**STAFF RECOMMENDATION**

**1411 N 14<sup>th</sup> Street**

**March 17, 2021**

**Application:** New Construction—Addition; Setback Determination

Figure 2: Left elevation for proposed rear addition to 1411 N 14<sup>th</sup> Street.

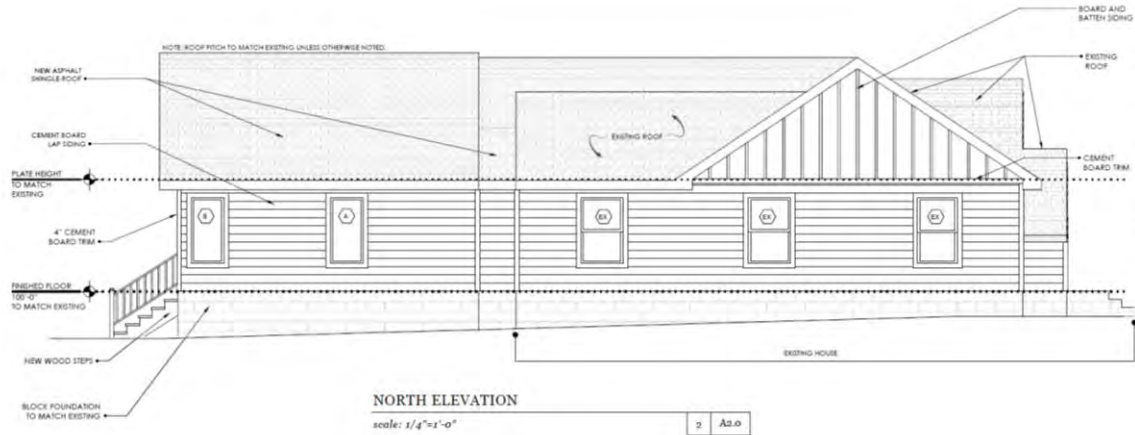
**Height & Scale:** The proposed addition ties into the existing roof at the ridge and extends toward the rear. After extending back approximately thirty feet (30') the roof of the addition will step up four inches (4'') higher than the existing roof ridge. Staff finds that the additional height will not have a negative impact on the historic character of the building as the amount is minimal and it occurs so far back. The eave height and floor height of the addition will match the corresponding heights of the historic house.

Staff finds the height and scale of the addition to be subordinate and to meet Sections II.B.1.a. and II.B.1.b. of the design guidelines.

**Setback & Rhythm of Spacing:** The scale of the addition is compatible with the historic house, as it matches the existing width after an inset of one foot (1') by two feet (2'). However, because the historic house sits only three feet, six inches (3'-6'') from the left side of the property, the addition will not meet the standard five foot (5') setback requirement. Staff finds the proposed setback to be appropriate because it matches the historic context.

**Roof form:** The roof of the addition will tie into the ridge of the existing roof and extend back, matching the existing height until it steps up four inches (4'') higher, thirty feet

(30') behind the existing ridge. The majority of the roof of the addition will match the pitch of the existing roof, with a lower pitched section over a recessed porch area on the left side.

Staff finds that the roofs of the addition are appropriate and meet Section II.B.1.e. of the Design Guidelines.

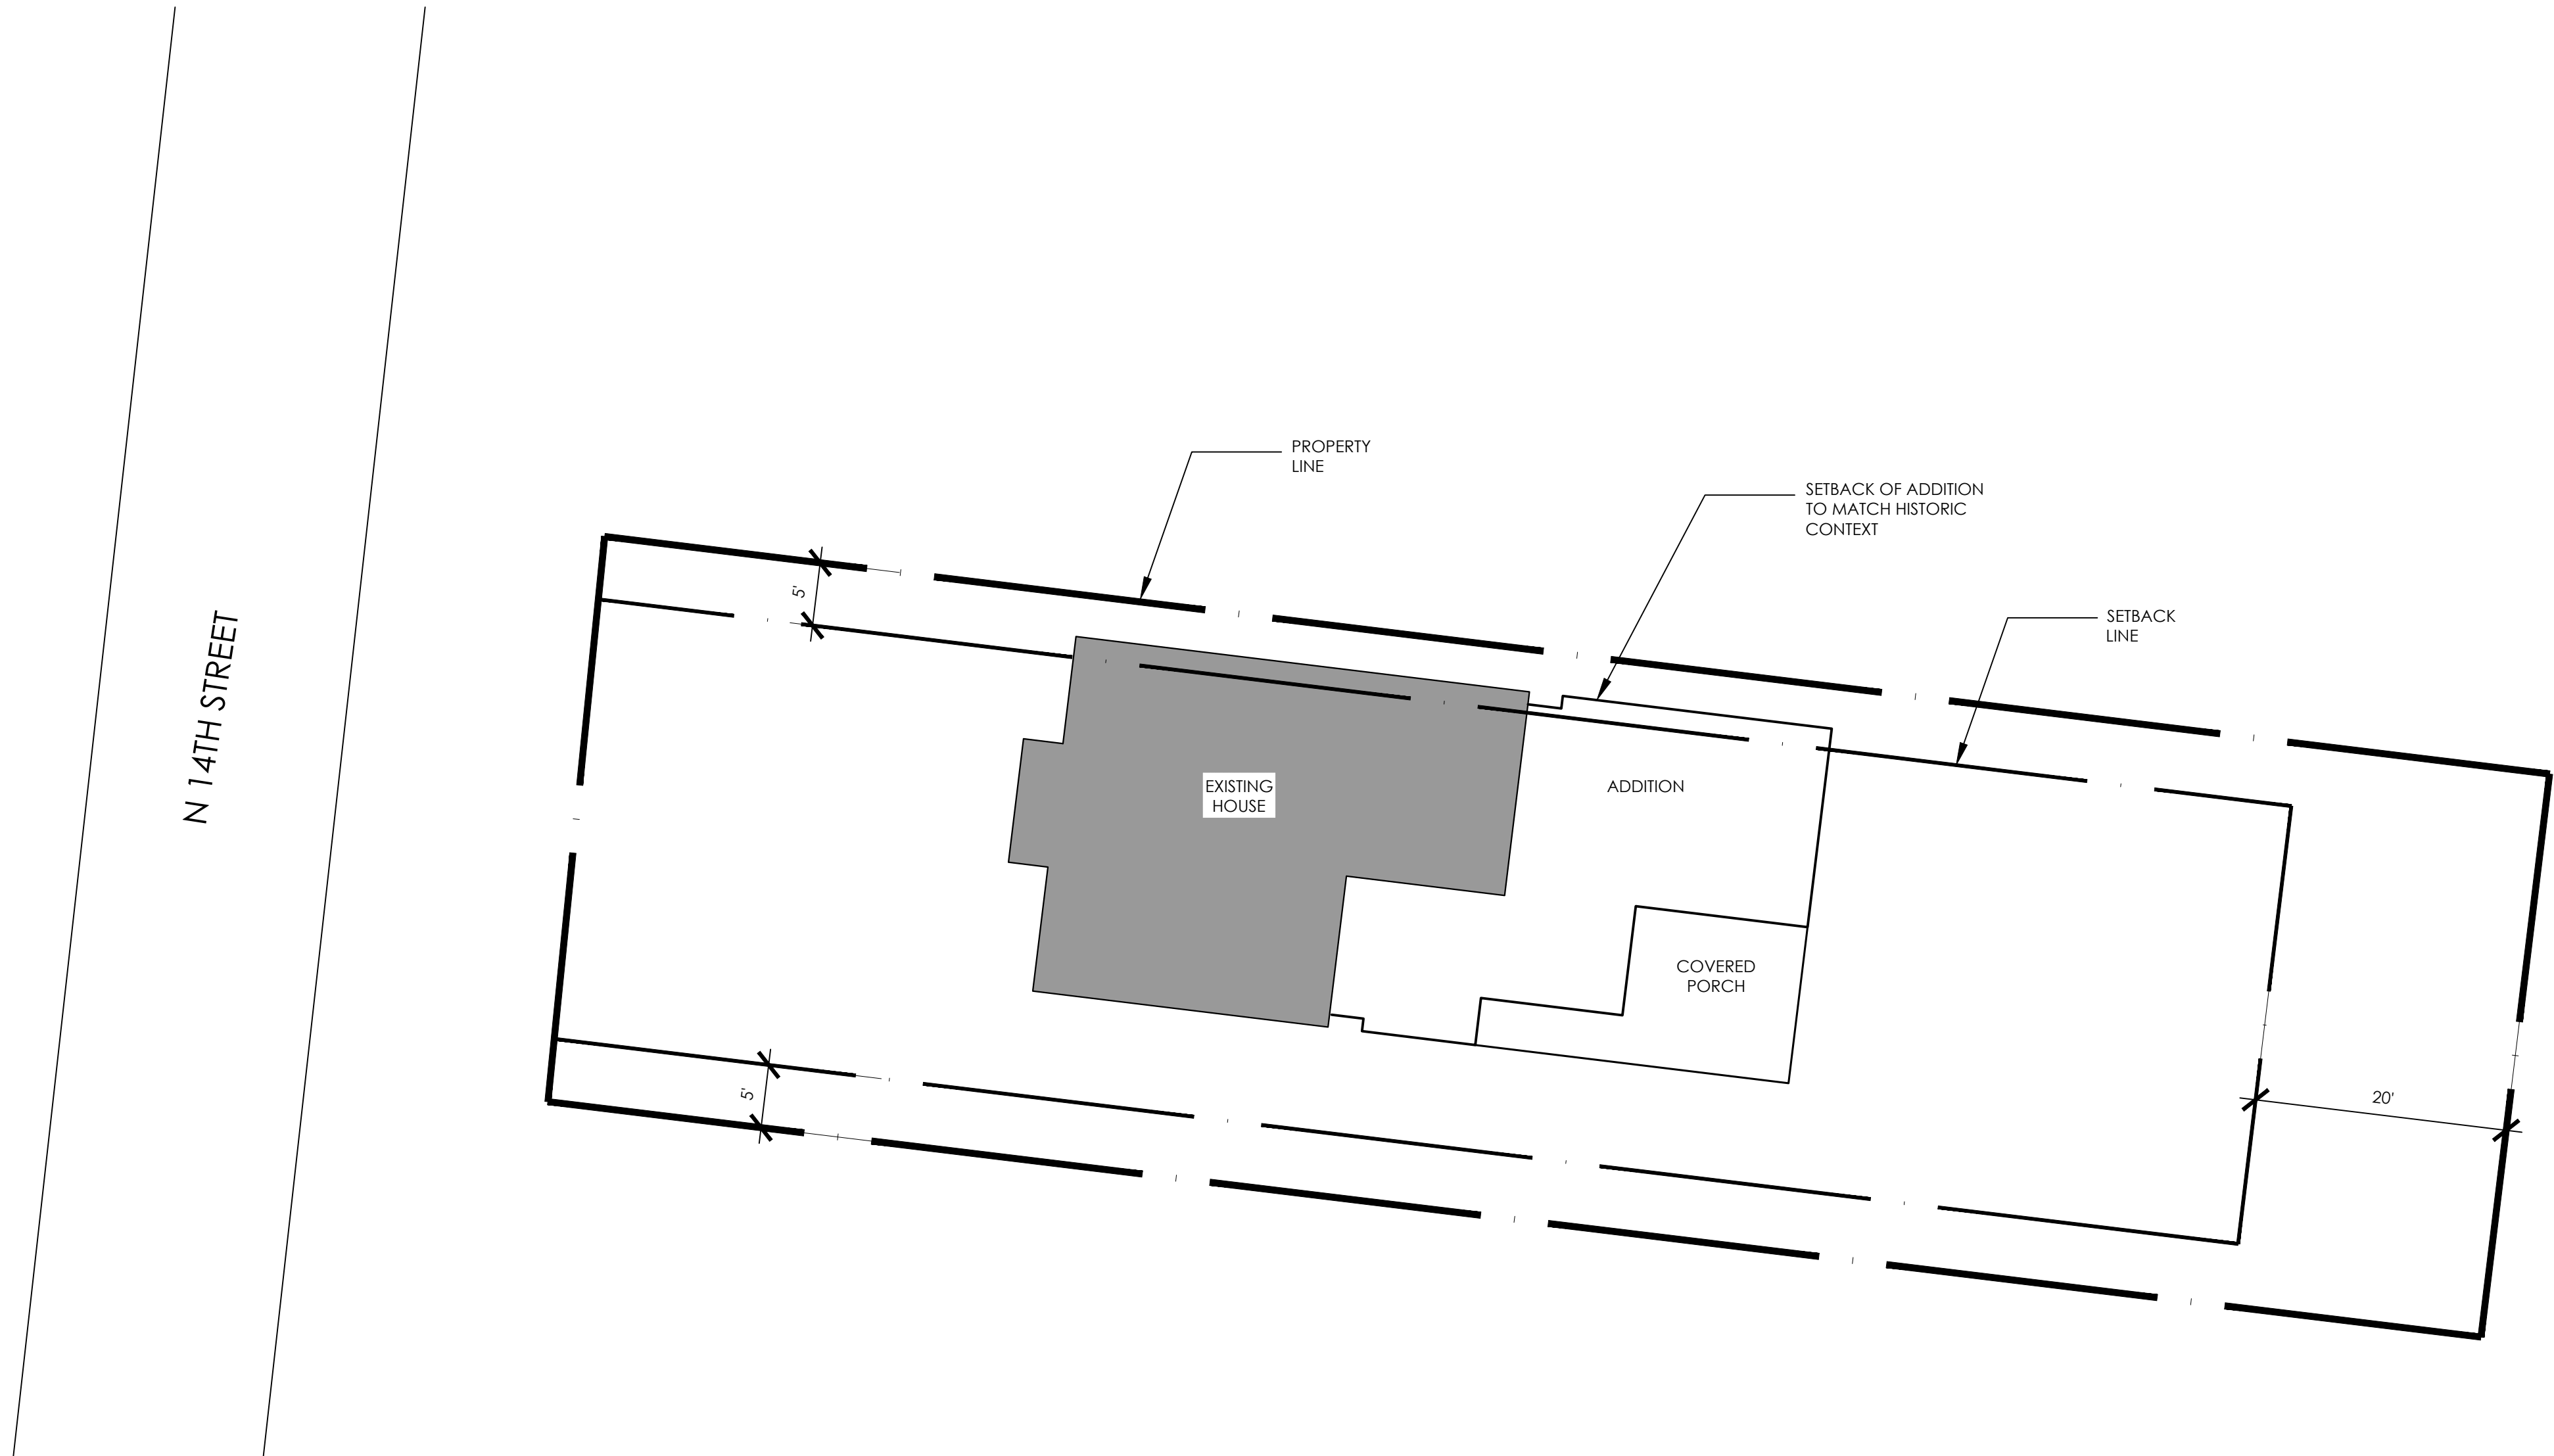
Appurtenances & Utilities: The HVAC condenser is currently located at the rear of the house and will need to be moved. Staff recommends that the HVAC is located behind the midpoint of the building, or on the rear of the addition.

With that condition, Staff finds that the project meets section II.B.1.i. of the design guidelines.

**DEMO PLAN**

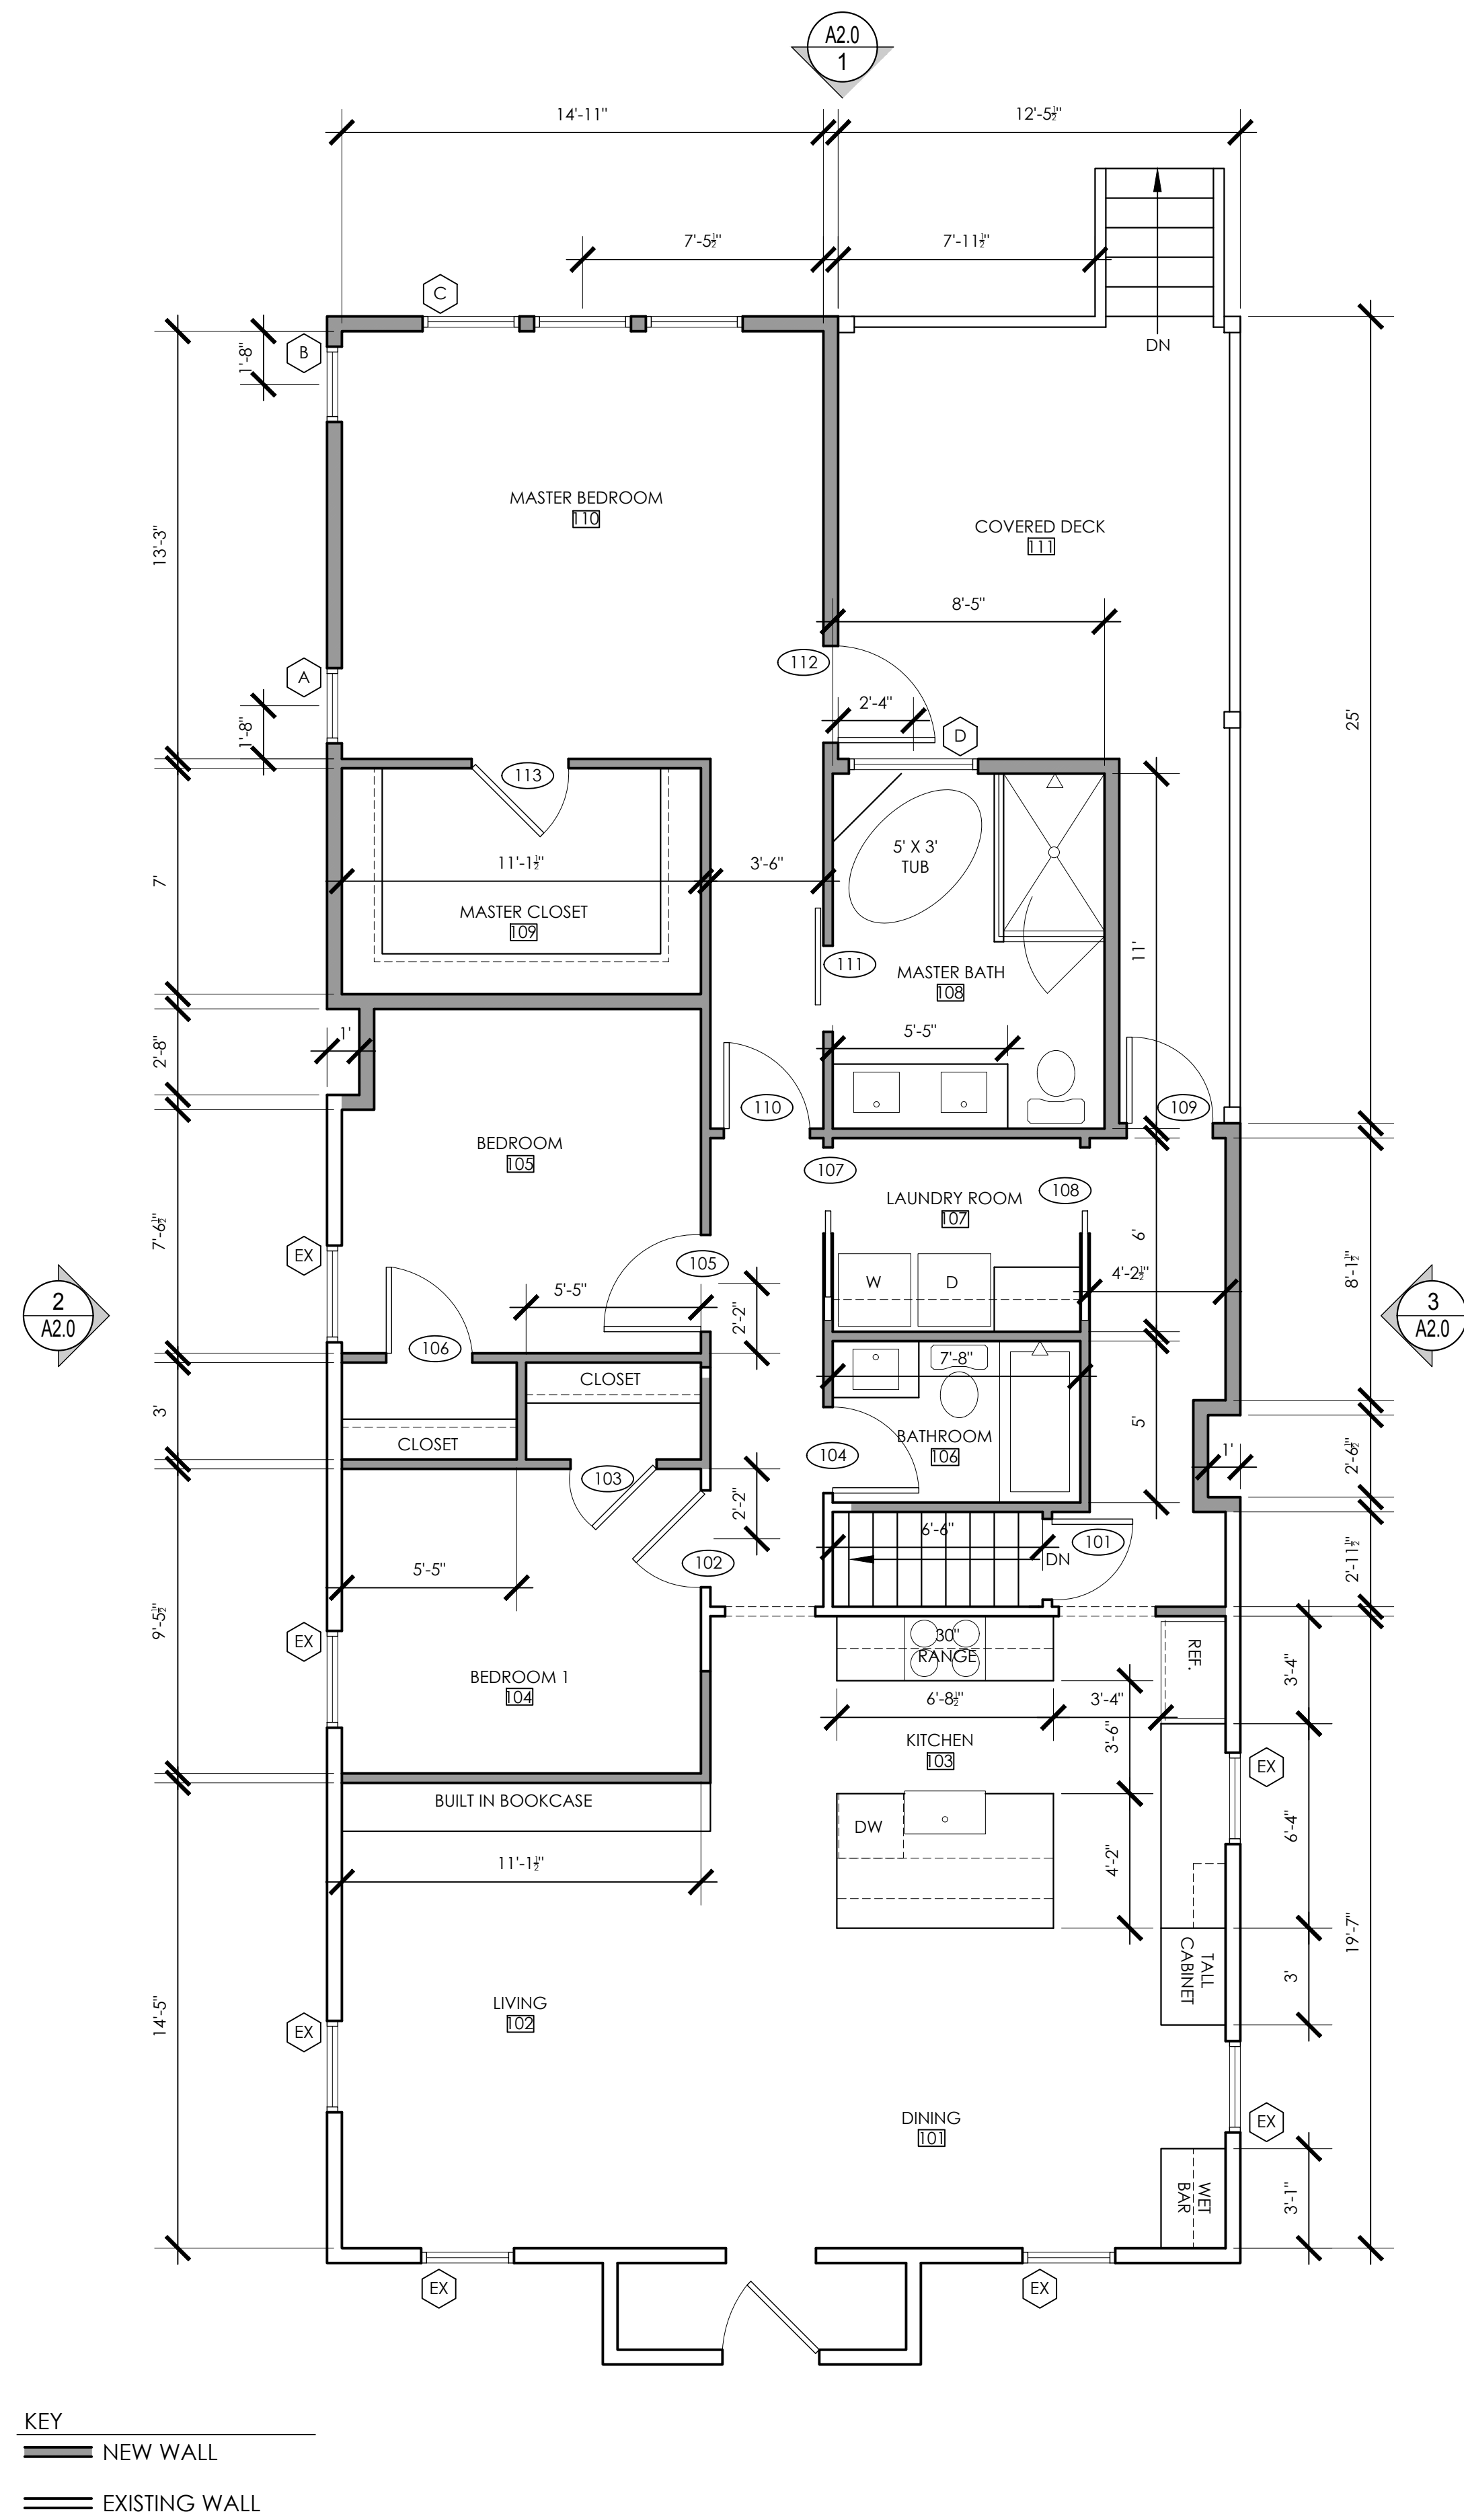
**Demolition:** The project involves demolishing portions of the existing rear wall and rear roof slope of the building to accommodate the new addition. These portions of the building appear to be original, but they are not visible from the right of way and do not contribute to the historic character of the house.

Staff finds that this partial demolition meets Section III.B.2 for appropriate demolition and does not meet section III.B.1 for inappropriate demolition.

**ROOF PLAN**

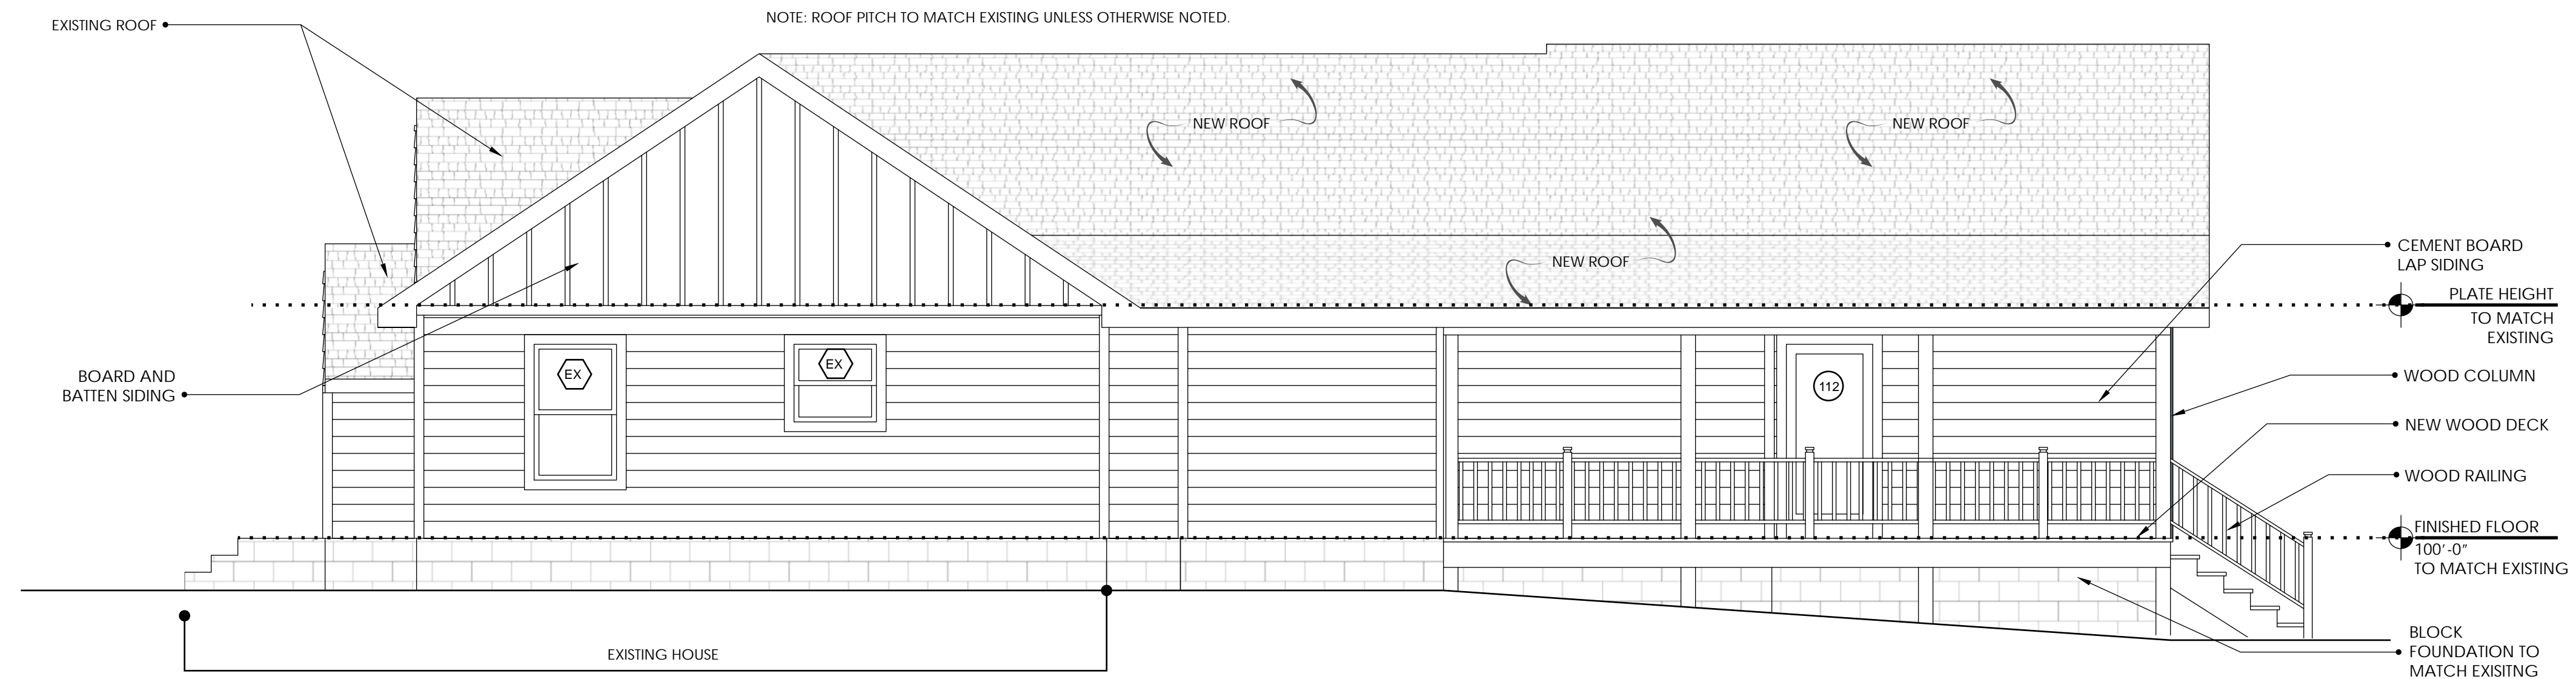
**Location & Removability:** The walls of the addition will step in one foot (1') on the left and right side before going back and stepping back out to match the existing width. The roof of the addition ties into the rear of the existing roof and does not impact the front or side slopes.
